AIRWORTHINESS DIRECTIVE

JANTAR SERIESTYPES AFFECTED:

Replacement of the aileron pivot pins and their securing M3 screws.

Ref: Replacement of pins connecting the aileron control lever on wing with the aileron itself.

Fig.1.

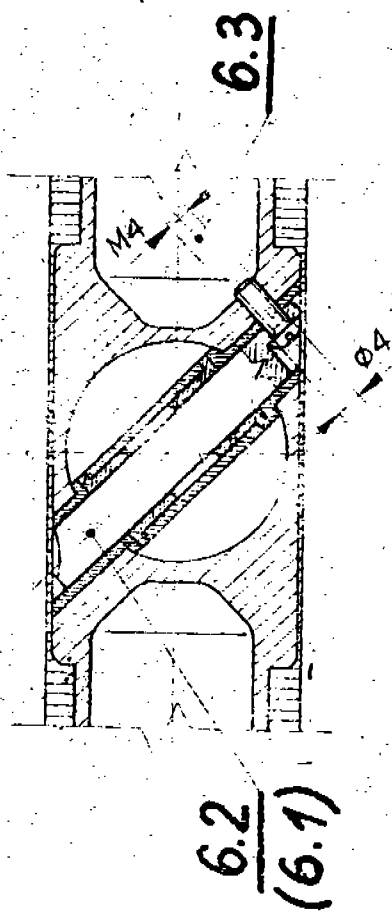
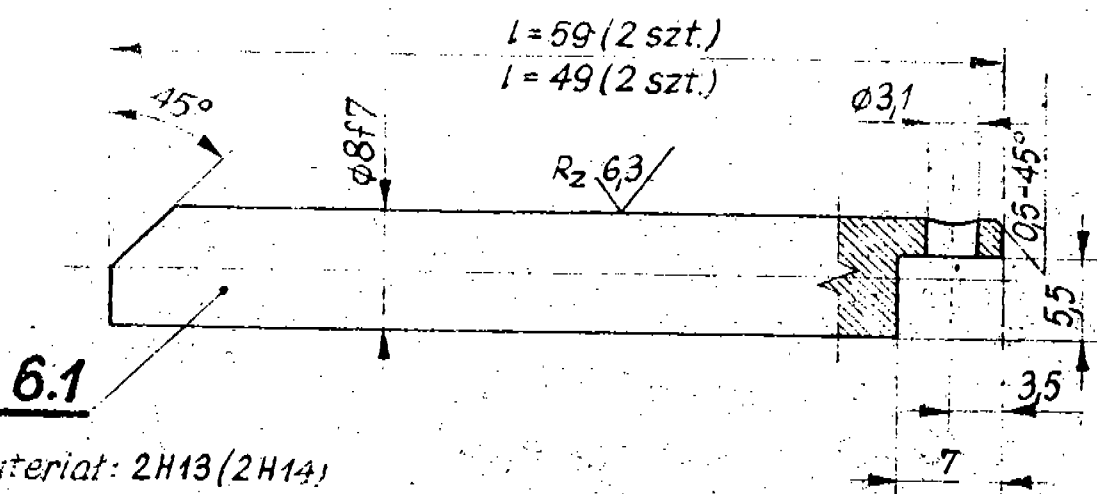
The change introduced by this Bulletin depends on the replacement of the pins connecting the aileron control system lever in wing with the aileron actuating member.

5.2 Remove the pin securing M3 screws and take out the pin. In case the M3 screw is sheared the pin rotating together with the lever cuts the elliptic hole in the glass-fibre skin. This hole should be glass-fibre covered and glued up.

5.3 Clean and grease the hole in lever and aileron actuating member. Put on the new pin covered with a grease / in case of gliders SZD-37, SZD-38 and SZD-38A the portion of pin protruding out of the aileron outline should be filed away.

Secure with the screw in case the M3 screw is sheared or the thread worn, the hole for the above mentioned screw should be reamed on $\varnothing 4$ and the hole in the aileron actuating member threaded on M4.

Fig. 2.

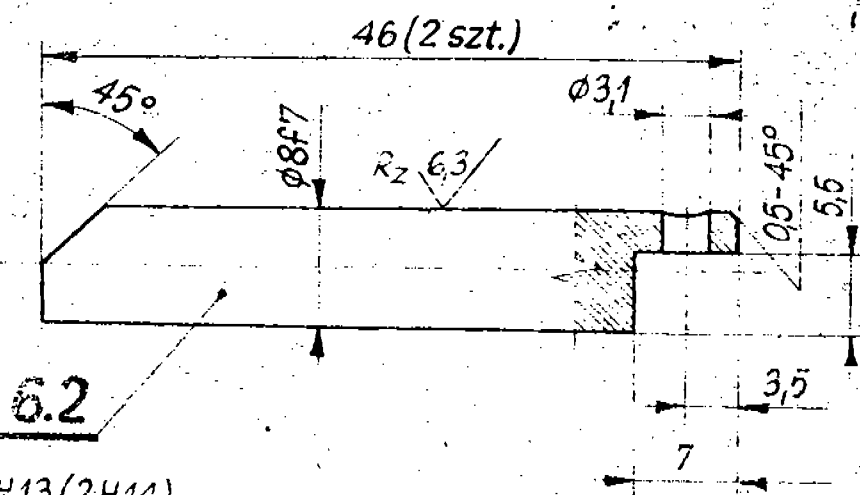
Instead of the pins protected against corrosion by means of oxydation the chromium plated or made of stainless steel one are replaced. In case the M3 screw securing the pin against shifting off is sheared or its thread in aileron actuating member is worn it should be replaced with M4 screws enclosed to this Bulletin. The procedures of replacement this screw are described in item 5.3 of this Bulletin.

- 6.1 Pins: 2 pieces of length $l = 49$ mm and 2 pieces of length $l = 59$ mm for gliders: SZD-37, SZD-38, SZD38-A, SZD-42-1 and SZD-42-2 Fig. 2, or;
- 6.2 Pins: 2 pieces of length $l = 46$ mm for gliders: SZD-48 and SZD-48-1 Fig 3.
- 6.3 Screws M4/10/ acc to BN-76/1112-04 standard - 4 pieces for gliders: SZD-37, SZD-38, SZD-38A, SZD-42-1 and SZD-42-2 or 2 pieces for gliders SZD-48 and SZD-48-1
